SEWAGE DISPOSAL SYSTEM

MARYLAND STATE DEPARTMENT OF HEALTH

SUBDIVISION Oak Forest Estates ROAD 425 Twin Arch Road LOT 2

SITE PLAN
 LOT 2, OAK FOREST ESTATES
 LISBON (4TH) ELECTION DISTRICT
 HOWARD COUNTY, MARYLAND

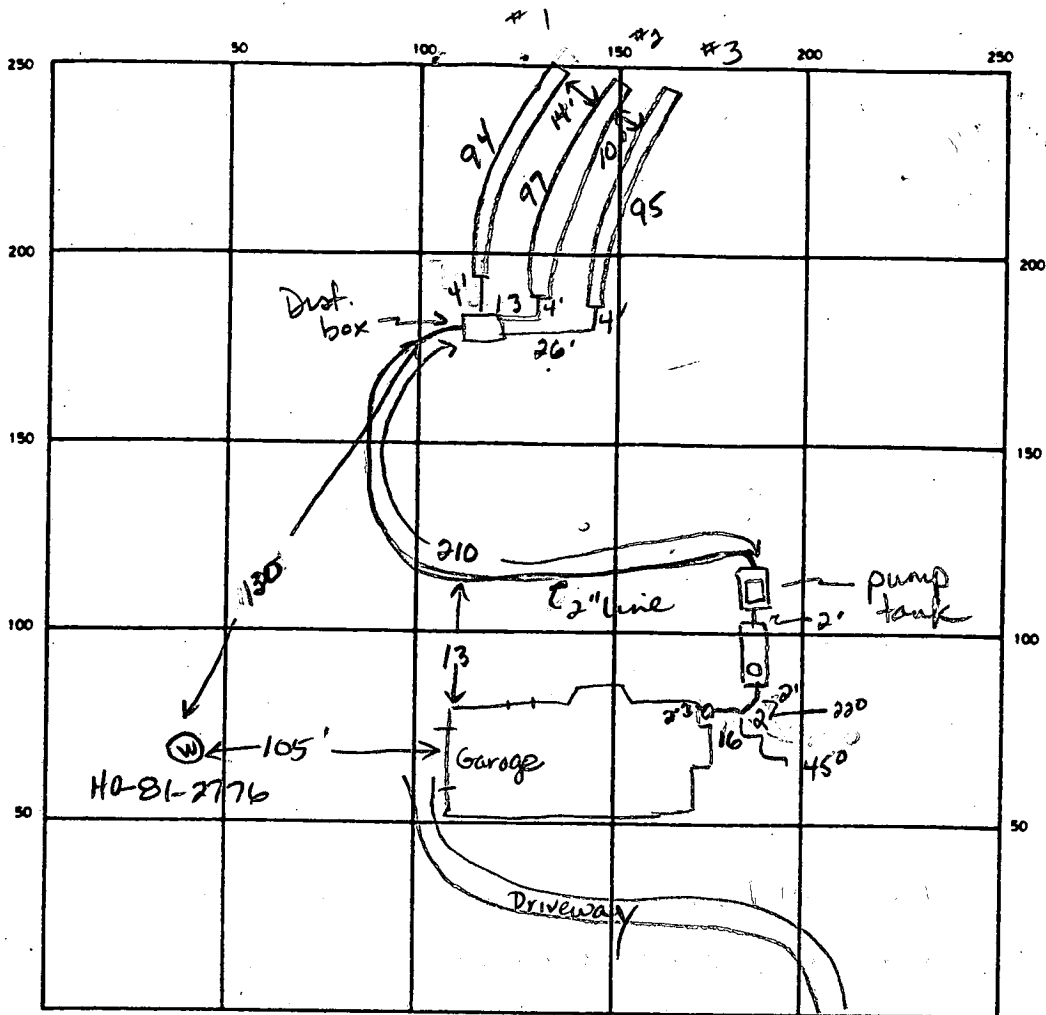
REMARKS 4-26-89 OK to cover trenches & pump line from house to dust. box. Grout around dust. box & septic tank. Change 90° bend before septic tank in sewer line to min. of 45° bend. Pump and alarms not installed. JEN 4-27-89 45° bend replaced previous 90° bend. OK to cover all lines beyond pump tank. JEN

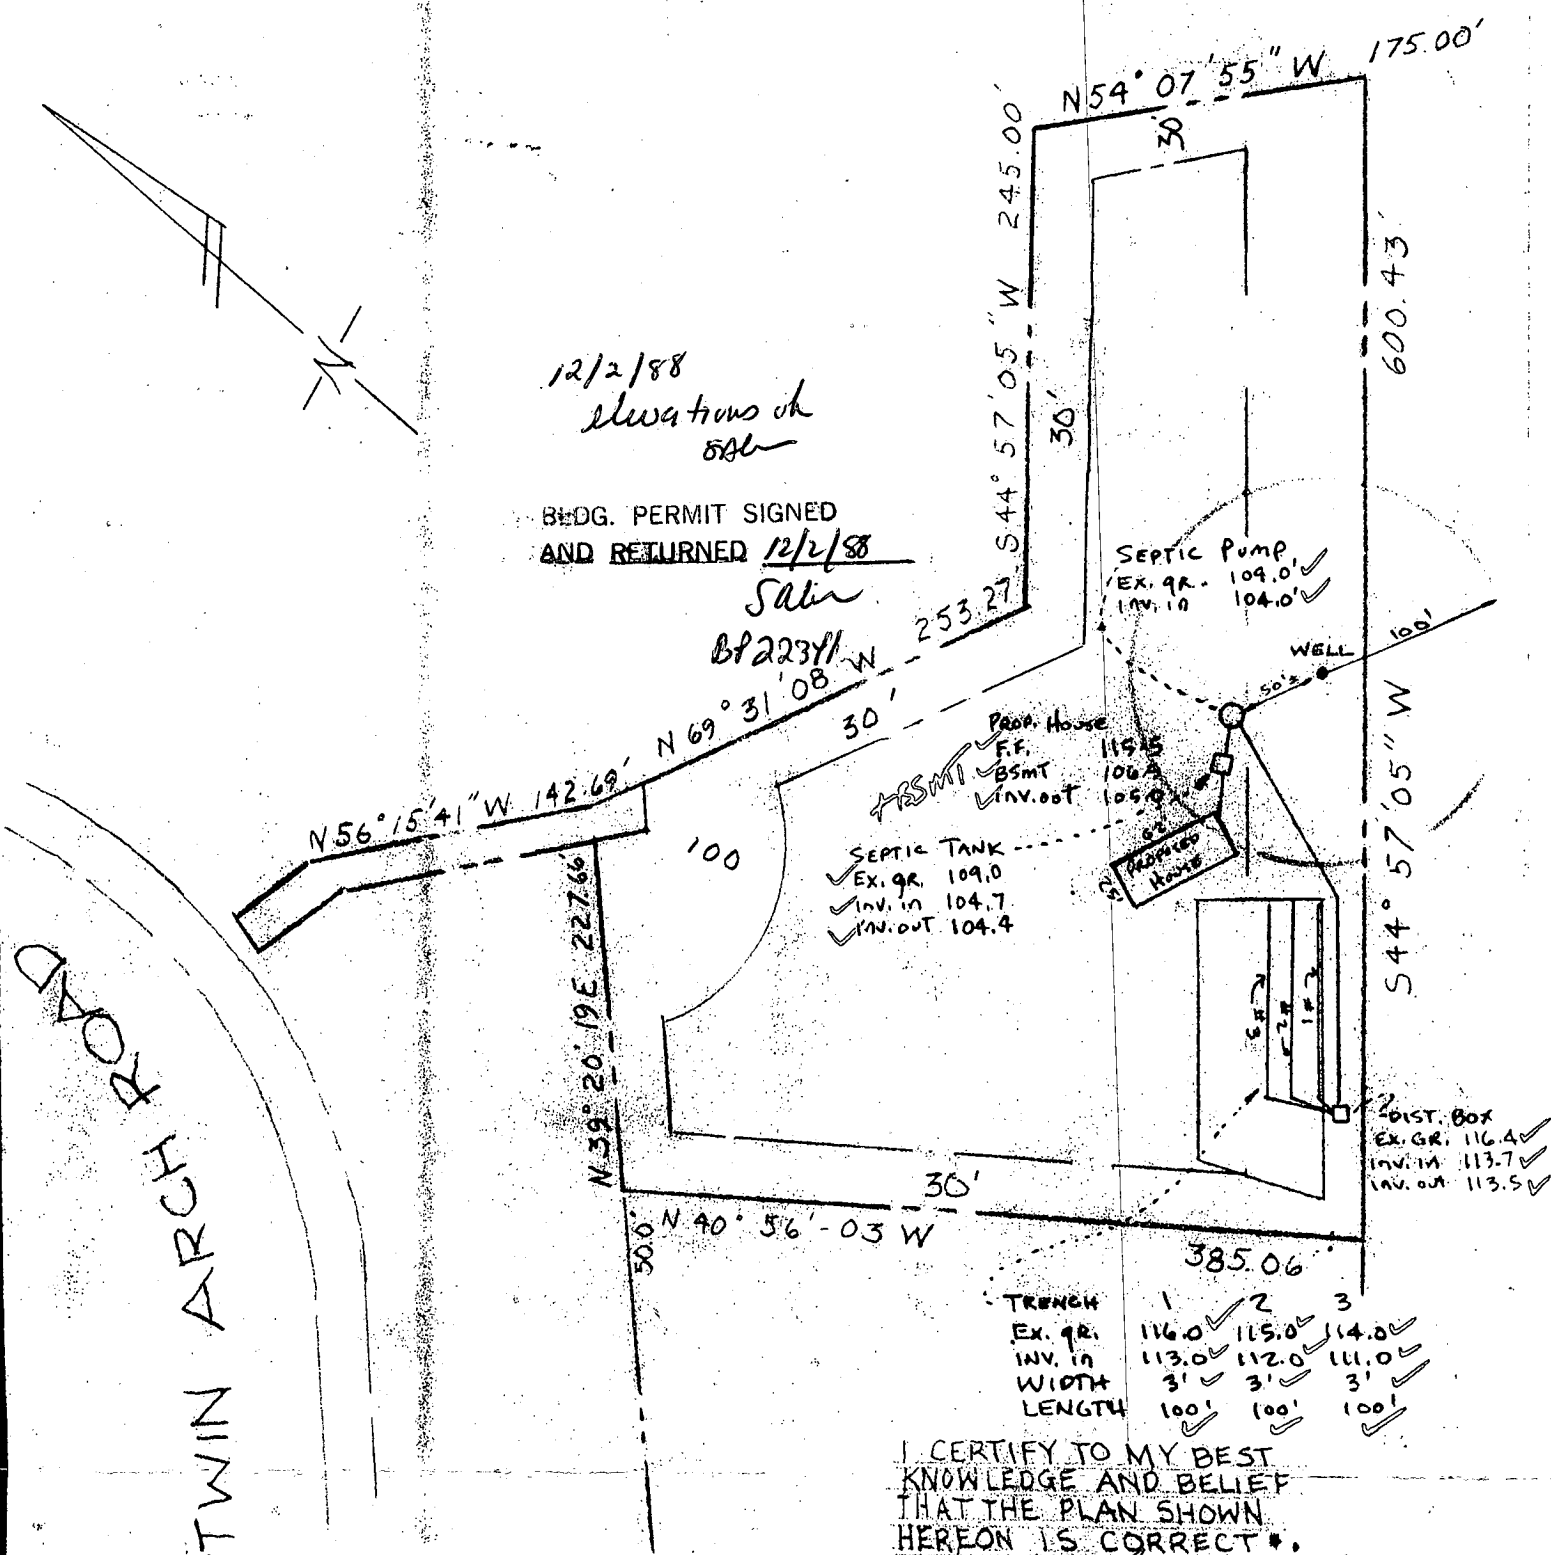
FLOW 150 GPD PER BR ✓
 DAILY FLOW 600 GPD OR 80.21 CU. FT. ✓
 WELL 4 FT DIA, 6.38 FT CAPACITY ✓
 PUMPING RATE 4 RUNS a day, 1.6 FT. PER RUN ✓
 20.05 CU. FT. OR 150 gal. per Run ✓
 4 BR ✓
